# Legalelectric, Inc.

September 6, 2024

RE: NoCapX 2020 - Initial CoN Comment on Merits  
MN Energy CON - Lyon Co. to Sherco Transmission Line  
PUC Dockets E001/CN-22-131 and E001/TL-22-132

Image 3.2: Xcel Energy’s Transmission System in Minnesota, North Dakota, and South Dakota<sup>35</sup>

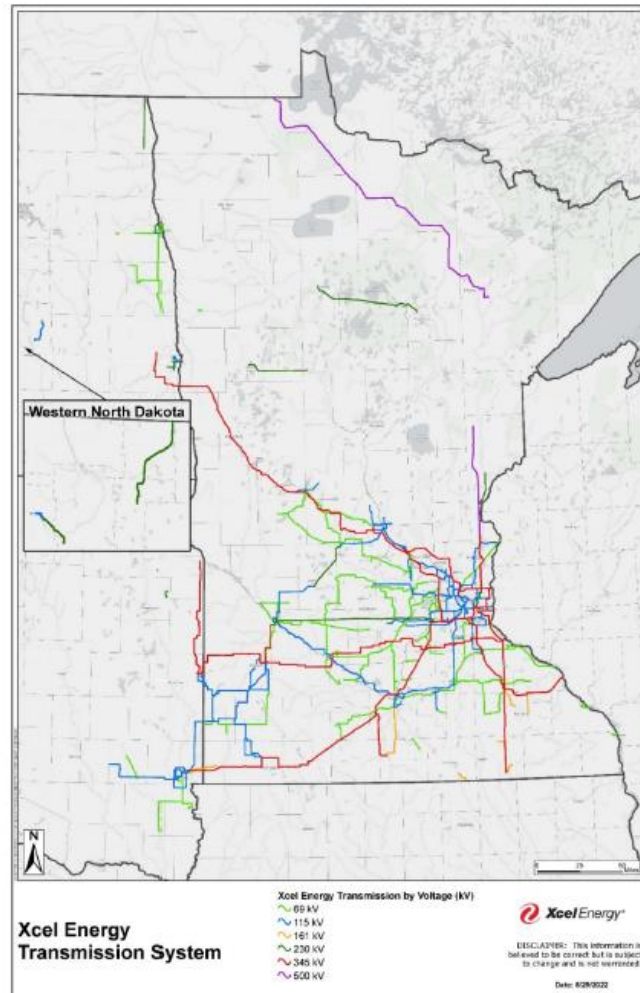
built but not shown on Xcel Energy’s map (Application, p. 36). Is it a matter of institutional memory? Many were not present through these projects, and too many were provided grant funding to support the transmission build-out.

Xcel’s map, by only including its own transmission (Application, p. 36) is missing transmission relevant to need in southwest and southern Minnesota:

Anyone can see the hole in Xcel's transmission map in southwest Minnesota where it plans to start its Lyon County-Sherco MN Energy CON transmission line. Application, p. 36. However, Xcel's map tells only part of the story – only Xcel's transmission is shown:

Specifically, the Commission must add to Xcel's map (Application, p. 36) the following projects for consideration of their impact on the southwest area of Minnesota, and must also add any other projects having an impact on southwest Minnesota. These have an impact on need:

- **MISO MVP 3, 4, &5. ITC's MVP 3** :PUC Dockets ET-6675/CN-12-1053; ET-6675/TL-12-1337;
- **Big Stone South-Alexandria-Big Oaks**, PUC Dockets E002, E017, ET2, E015, ET10/CN-22-538;
- **Northern Reliability Project**, PUC Dockets E015,ET2/CN-22-416 and E015,ET2/TL-22-415;
- **Brookings-Lyon Co. & Helena-Hampton Uprate**: PUC Dockets ET-02/CN-23-200 and ET-02/TL-08-1474; and
- **Mankato-Mississippi transmission project, a/k/a Wilmarth-Tremval (WI)**: PUC Dockets E002/CN-22-532 and E02/TL-23-157.

**Figure 1: Big Stone South – Alexandria – Big Oaks  
345 kV Transmission Line Project**

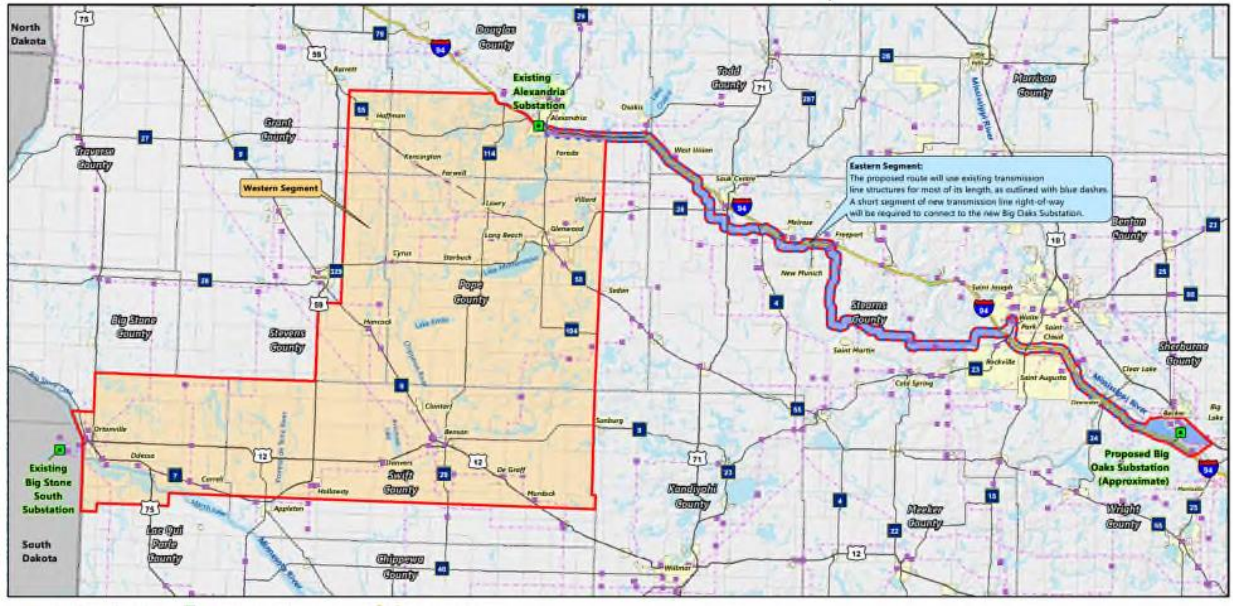
A. **TYPE & TIMING – Big Stone-Alexandria-Big Oaks would bring electricity from Big Stone to the Sherco area**

The Commission must consider need the transmission line proposed in light of the application for a transmission line from Big Stone to Alexandria to Big Oaks, essentially from the Lyon Co. area to the Sherco area. Yes, Big Stone is near Lyon County, proposed for the start of MN Energy CON. Why another? For some reason, no commentator other than NoCapX has raised this project, which could connect to Sherco substation, in relation to the MN Energy CON line, and could/would have an impact in loading in southern Minnesota and the Sherco substation. See

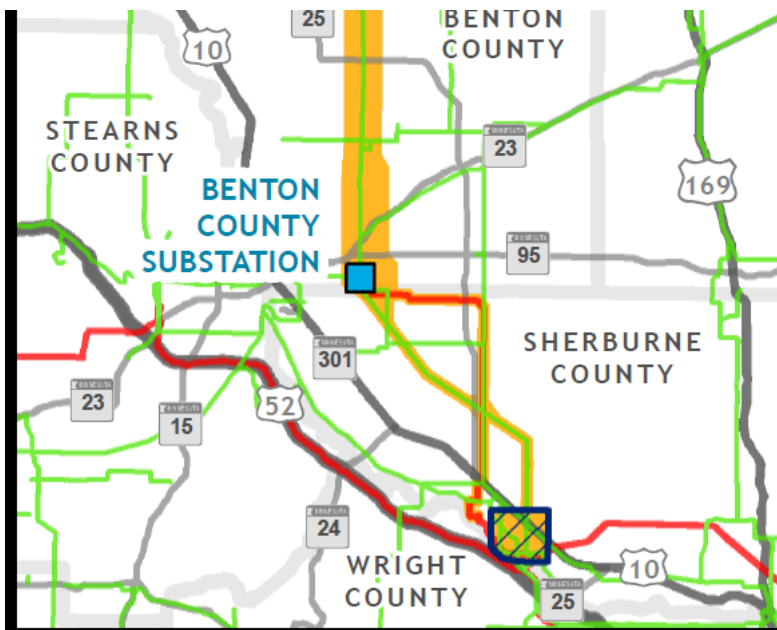
**B. TYPE & TIMING – the Northern Reliability Project would bring electricity to the Sherco area**

The Northern Reliability Project, E015,ET2/CN-22-416 and E015,ET2/TL-22-415, which runs from the Itasca County substation near Grand Rapids down to the “Big Oaks” substation near Sherco. For some reason, only NoCapX 2020 has raised the current transmission projects in the area, and this is yet another project that could interconnect at Sherco:

Figure 1

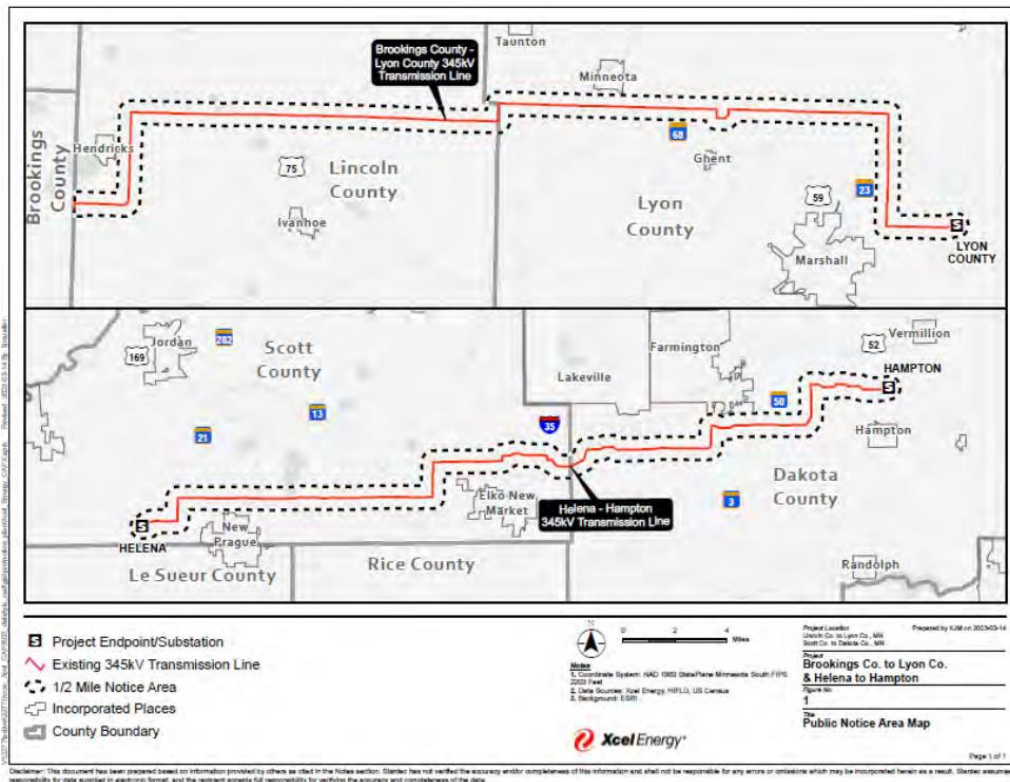
**C. TYPE & TIMING: The CapX 2020 Brookings line is now being uprated, double-circuited, and would bring generation out of the Lyon Co. area**

Xcel is double-circuiting two portions of its “Brookings-Hampton” CapX 2020 transmission project. No CapX 2020 was an initial intervenor in this docket, ET-2/TL-08-1474, together with United Citizens Action Network (U-CAN). See also ET-02?CN-23-200. This transmission uprate will increase capacity out of Lincoln and Lyon Counties. Again, for some reason, no commenter other than NoCapX 2020 has referenced this uprate, which logically has an impact on transmission loading in southern Minnesota and transmission to the metro and points east.

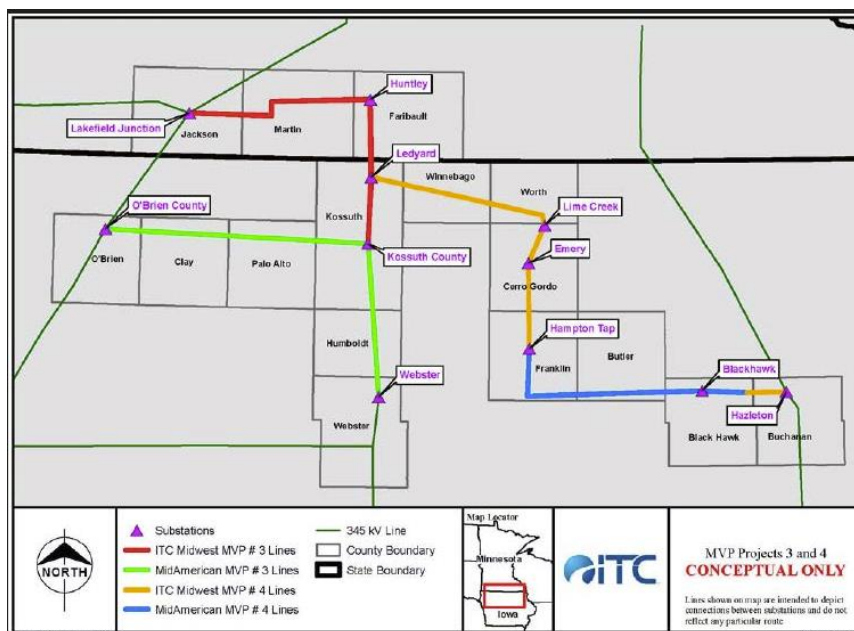
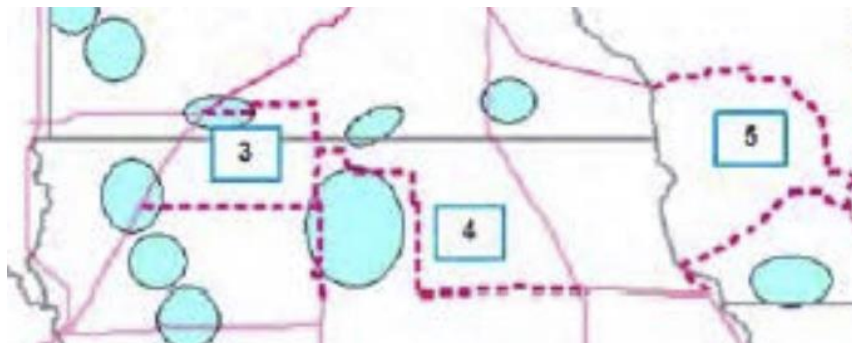
**E. XCEL FAILS TO INCLUDE THE ITC LINES, MVP 3, 4, & 5 ON ITS MAP**

Xcel fails to include significant and relevant transmission existing in southern Minnesota that is available for generation in southwest Minnesota – the ITC transmission, MVP projects 3, from Lakefield Junction to Huntley in Minnesota, to Ledyard and Kosseth County substation in Iowa:

In considering need for Xcel's MN Energy CON, the ITC lines MVP 3 and 4 in Minnesota and into Iowa, and MVP 5, the northern part known as Badger Creek/CapX 2020 from La Crosse to North Madison, and the southern part known as Cardinal-Hickory Creek, going across the Mississippi towards Madison.

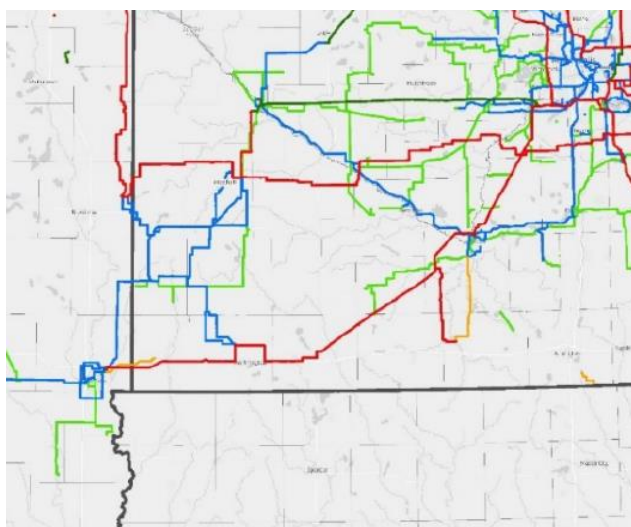
**F. ANY NEED CONSIDERATION CAN ONLY BE MADE IF THE FULL RANGE OF EXISTING AND PROPOSED TRANSMISSION PROJECTS IN AND AROUND SOUTHWEST MINNESOTA ARE DRAWN ON THE MAP!**

Xcel's transmission does not exist in a bubble. As we say in transmission, "It's all connected!" As above, the Commission must start with that Xcel map and add the existing ITC lines, MVP projects 3, 4 and 5, which draw energy out of southwest Minnesota and consider the impact on capacity. The Commission must also consider all those transmission projects now before it that have an impact on the transmission system and transmission capacity. The Commission must draw existing projects not owned by Xcel on the map, must put these applied for projects on the map, and consider the impact of all these lines on transmission capacity. Xcel is revealing only part of the picture.

**Figure 3-2: NSP System Median Base Summer Peak Demand (MW)**  
(Includes modeled EE Adjustment)

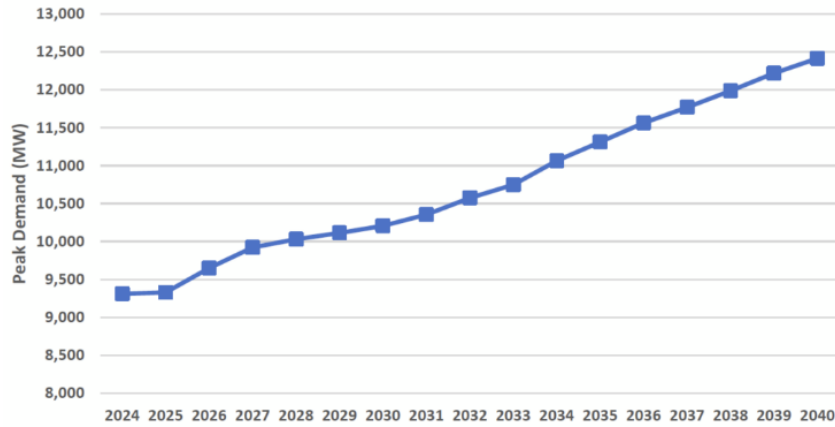
What demand projection? Look at Xcel's convenient claim of an annual 1.8% increase in peak demand, as of its just filed Integrated Resource Plan, PUC Docket RP-24-67. It contains a chart

that is eerily reminiscent of the grossly overblown CapX 2020 demand projections of 2.49%, see IRP Chapter 3, page 2 of 29:

That IRP projection is laughable, and hopefully not taken seriously by the Commission. Referring to their CapX peak demand projections as “grossly overblown” is not hyperbole. Here is their peak demand as taken from the Xcel Energy 10-K filings with the SEC:
